CHAPTER 4 AFFECTED ENVIRONMENT, ENVIRONMENTAL CONSEQUENCES, AND AVOIDANCE, MINIMIZATION AND/OR MITIGATION MEASURES

The following changes to Draft EIS/EIR Section 4.4, Visual Resources, are needed to provide minor corrections to the text as well as to reflect the changes to the Hybrid Alternative/SRA introduced in this Final EIR.

Figure 4.4-12a Key Viewpoint 5 - BRT Stop, Hybrid Alternative (Fillmore Street)

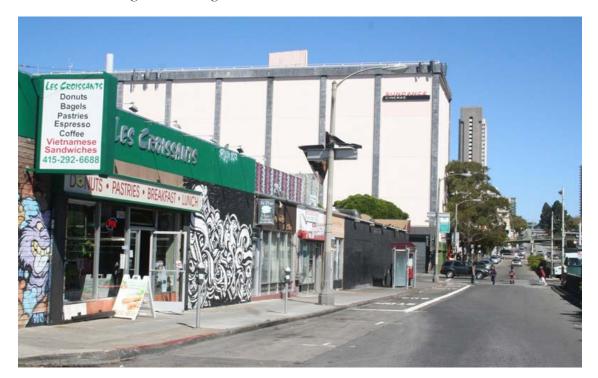
Page 4.4-39, staff-initiated modifications

Similar to Alternative 2 regarding proposed BRT stops; local-only stops would be in different locations than those of Alternative 2. In addition, the Hybrid Alternative would relocate reconfigured on-street parallel parking spaces on both sides of Geary Boulevard between Webster and Laguna.

Unlike the other build alternatives, the Hybrid Alternative would not remove the Webster Street bridge (refer to Figure 4.4-12a).

B. Simulated view looking east showing mature vegetation and the Webster Street pedestrian bridge
